World Forum for Harmonization of Vehicle Regulations

Working Party on General Safety Provisions

Proposal for the 03 series of amendments to Regulation No. 46 (Devices for indirect vision)

Submitted by the Working Party on General Safety Provisions *

Figure A
Diagram of the blooming measurement set-up.

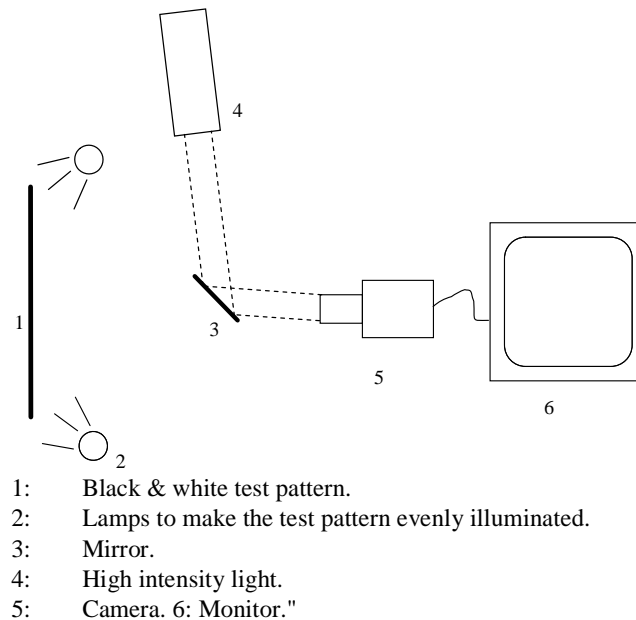
Insert new paragraphs 6.2.2.2.1.1. to 6.2.2.2.1.4., to read:

- 6.2.2.2.1.4. An example of the set-up is given in the figure A below.

"6.2.2.2.1.1. A black and white test pattern, having a minimum contrast ratio of 20 shall be positioned in front of the camera.

The test pattern shall be evenly illuminated at an illumination of 3000 ± 300 Lx.

The test pattern shall be medium gray on average and cover the complete area viewed by the camera; the camera shall view no other objects than the test pattern.

- 6.2.2.2.1.2. The camera shall be hit by a (simulated sun) light of 40 kLx, spanning an angle between 0.6 and 0.9 degrees with an elevation angle of 10 degrees (directly or indirectly via a mirror) removed from the optical axis of the sensor.

The light source shall:

- (a) have a spectrum D65 with a tolerance of $\pm 1500\text{K}$,
- (b) be homogeneous in space and time within a tolerance of 2 kLx.

The emission of the light source in infrared shall be negligible.

- 6.2.2.2.1.3. There shall be no ambient illumination of the monitor during the test.

Figure 2
Typical relationship between the size of the triangle and the fraction of correct responses.

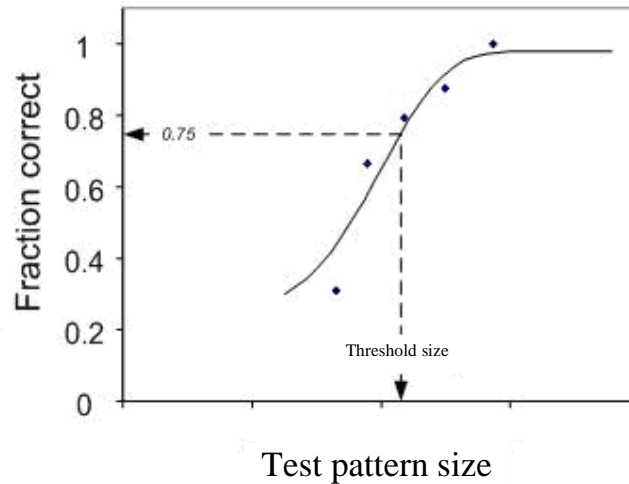
Annex 10, paragraphs 1. to 1.2., amend to read:

The Landolt C test can be used to determine the smallest discernable detail of the camera-monitor system. However, for sensor systems it is more suitable to use the TOD (Triangle Orientation Discrimination) method which is similar to the Landolt C method, but involves equilateral triangular test patterns. The Triangle Orientation Discrimination method is described in detail by Bijl & Valeton (1999), who provide practical guidelines on how to perform a TOD measurement. In the method, triangular test patterns (see Figure 1) are viewed through the viewing system under test. Each triangle can have one out of four possible orientations (apex up, left, right or down) and the observer indicates/guesses for each triangle its orientation. When this procedure is repeated for many (randomly oriented) triangles of different sizes the fraction of correct responses can be plotted (see Figure 2), and increases with test pattern size. The threshold is defined as the point at which the fraction correct crosses the 0.75 level and can be obtained by fitting a smooth function through the data (see Bijl & Valeton, 1999). Critical perception is reached when the critical object diameter equals two times the width of the triangle at threshold size. The smallest discernable detail (ω_c) is equal to 0.25 times the width of the triangle at threshold size. This means that, from the threshold triangle width w (in m) and the distance between test pattern and the camera D (in m) the smallest discernable detail ω_c (in arcmin) is calculated as follows:

$$\omega_c = \frac{w}{4 \cdot D} \cdot \frac{180 \cdot 60}{\pi}$$
